**Revision of Manuscript Number:** IEEE-TPWRS-01391-2021, version 1 January 8, 2022  
**Journal:** IEEE Transactions on Power Systems  
**Author:** Abhishek Halder, Kenneth F. Caluya, Pegah Ojaghi, Xinbo Geng

### Response to decision:

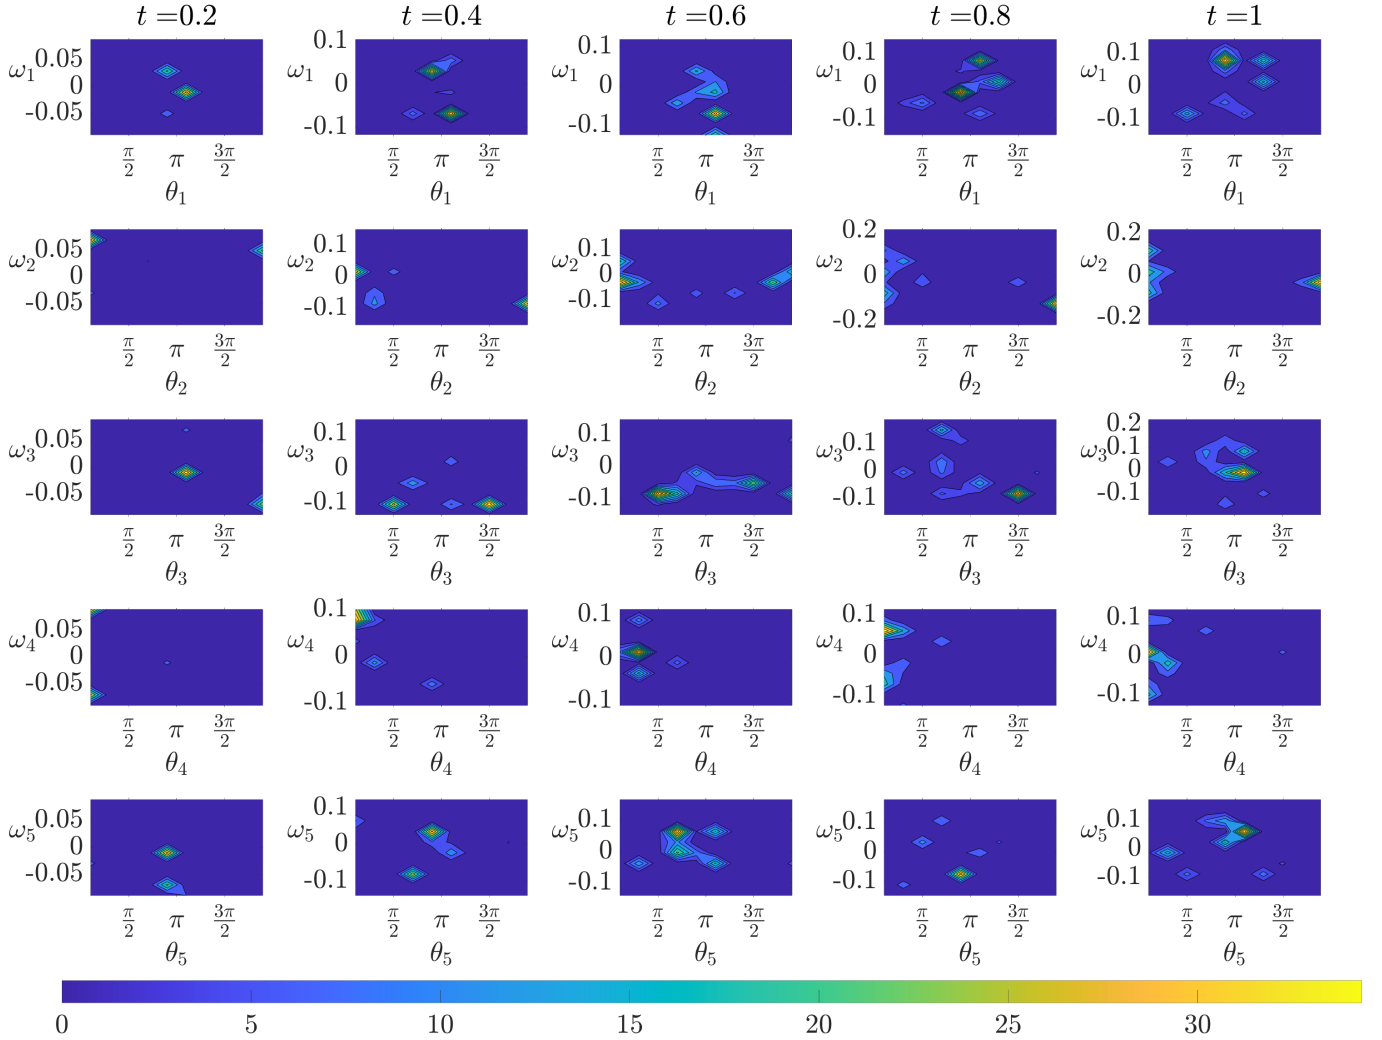
*Figures 5 and 6 are unreadable.*

**Response:** Thanks for this comment. In the previous version, the strict 10 page limit enforced small figure sizes. In the revised manuscript, Figures 5 and 6 are made larger. Also, the Fig. 6 in the revised manuscript shows the transient  $(\theta_i, \omega_i)$  bivariate marginals for all the five generators in Case II; the previous version showed the same only for the generator 4 (bus 6). We believe these changes have improved clarity.

Regarding the style of plots, we had considered plotting the bivariate marginals as planar contour plots (as in Fig. 1 in this rebuttal document) but decided against it because of the following two reasons.

First, in our opinion, this kind of plot is scientifically misleading as they hide the fact that these bivariate marginal PDFs are not really supported on the plane, or the subsets thereof, but instead have cylindrical supports. Our message that the proposed method explicitly accounts this manifold geometry in the computation, would be missed had we chosen to make the plots as per populist cognitive bias on behalf of the readers. That the planar plots evoke a sense of familiarity cannot be a scientific argument in favor of it.

Second, the planar contour marginal plots require additional mental efforts from the readers to correctly parse the statistical information conveyed. For instance, consider the fourth column, second row subplot in Fig. 1 in this rebuttal document. It is upon the reader to parse that the two high probability regions on the left and right of that subplot are actually referring to the same angular high probability region around  $\theta_2 = 0$  rad, thanks to the periodic boundary condition on the angular variable. Our philosophy of technical communication is that the onus is on the authors, not on the readers, to clarify the scientific information as correctly as possible. And yes, we are aware that many papers in the power system literature make plots in the rectangular domain ignoring the manifold nature of the support, which in our experience, continue to add pain to the graduate students and beginning researchers trying to decipher the statistical meaning conveyed in those plots. We prefer ours not be contributing to the accrual of such pain, and instead make plots that depict the variables as they are.
